Title		<i>Laser PD Calibrator Head</i>		LIGO Laboratory California Institute of Technology Massachusetts Institute of Technology			
Size: A	DCC Number: D1200690	Revision: v4	Engineer: R. Abbott	Date: 6/22/2012		Time: 5:30:30 PM	
File: C:\Rich's Files\Mycadfiles\ISC\Laser Calibrator\LaserCal.SchDoc				Sheet 1 of 1

Laser PD Calibrator B1200690-v4

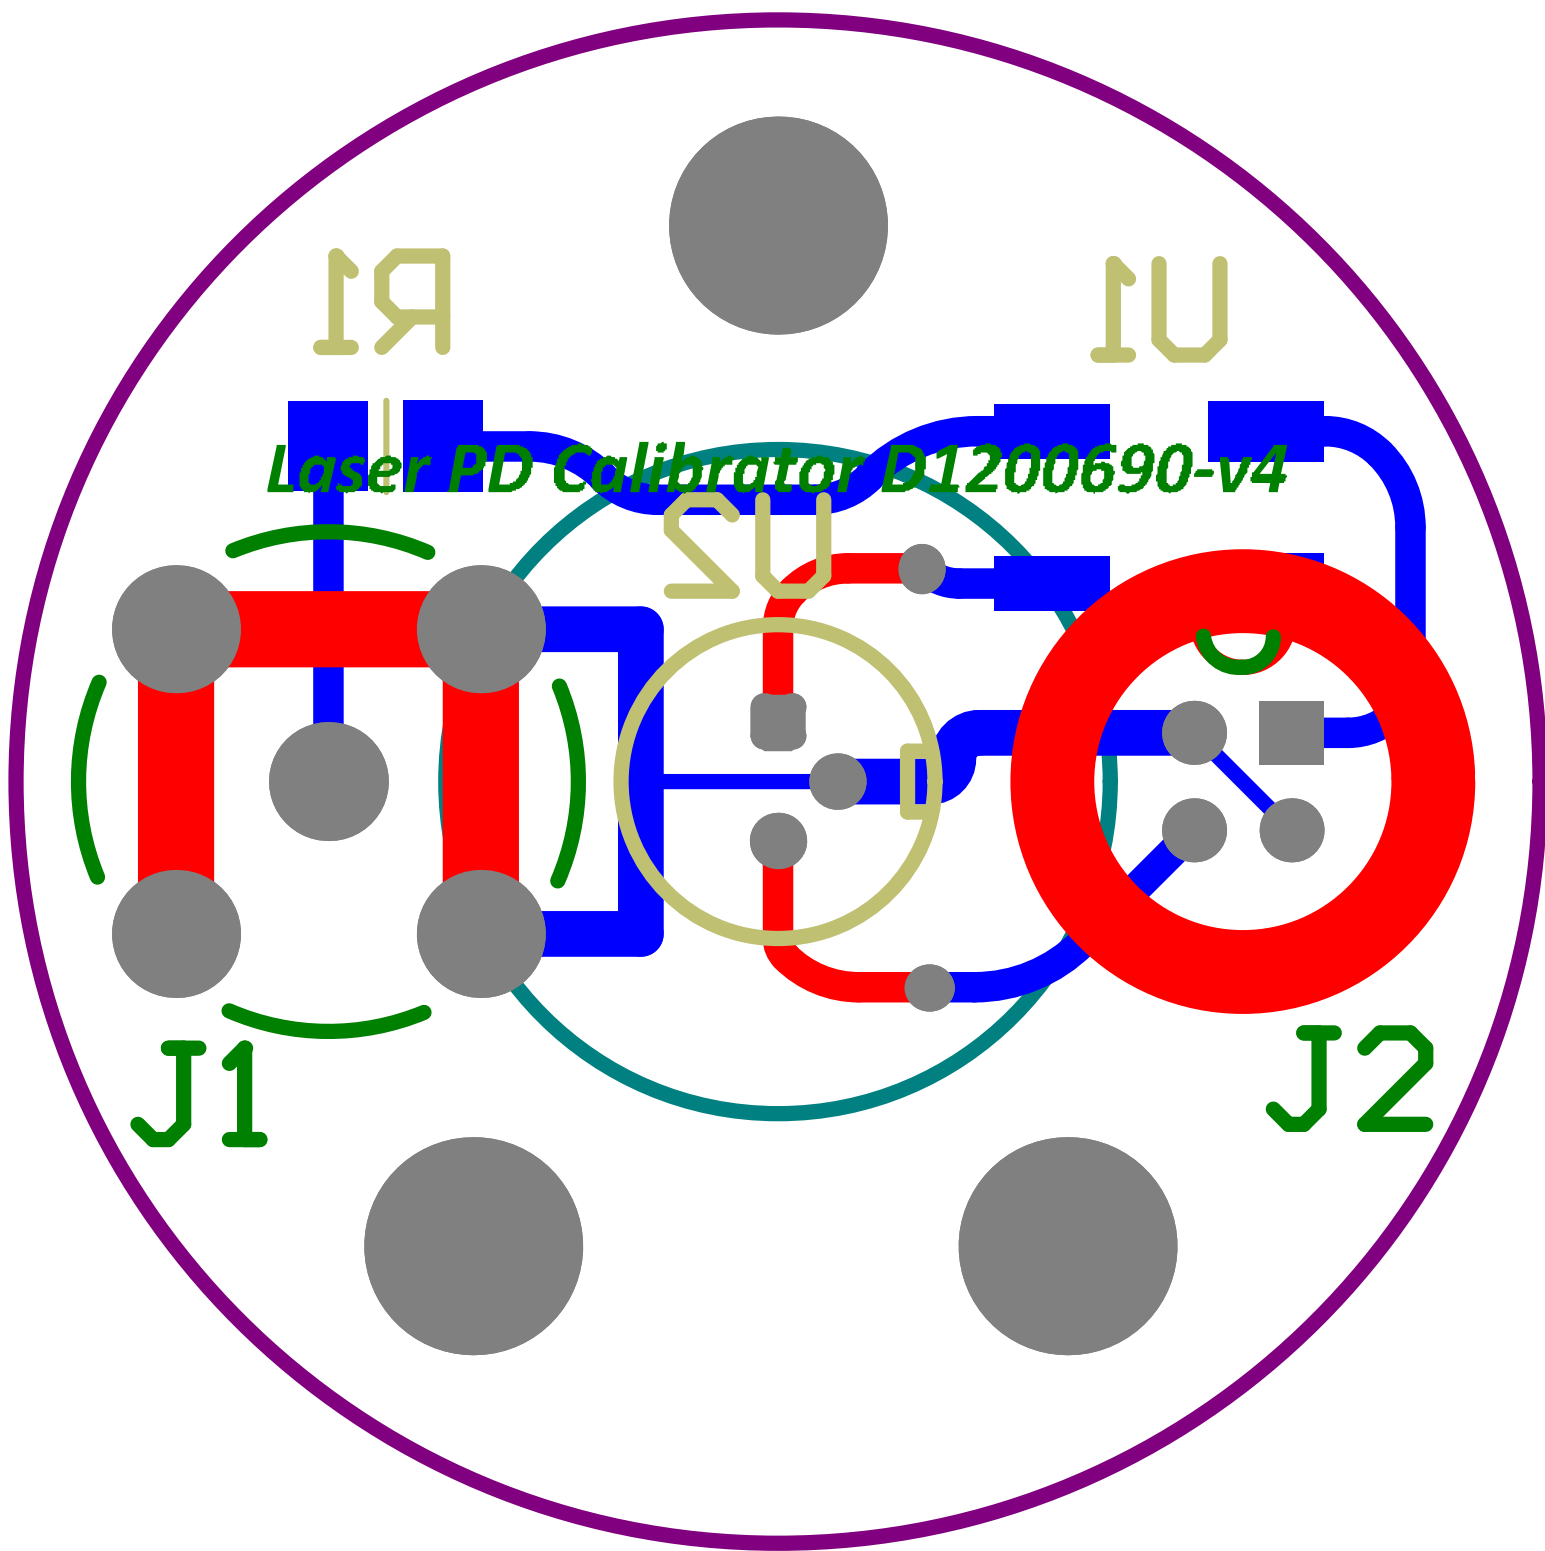
- Rev. 1 - Initial DCC entry
- Rev. 2 - Did some schematic cleanup of typos
- Rev. 3 - First PCB that was manufactured
- Rev. 4
 - Revised PCB and Schematic.
 - Fixed Microtech connector to be able to solder to PCB for added strength.
 - Moved in the standoff holes to better clear the lens tube.
 - Changed the laser diode from the VCSEL to the L980P010 diode.
 - Reduced diameter of PCB to clear lens tube better.
 - Changed from PCB standoffs, to simple screw mounting and spacer washers
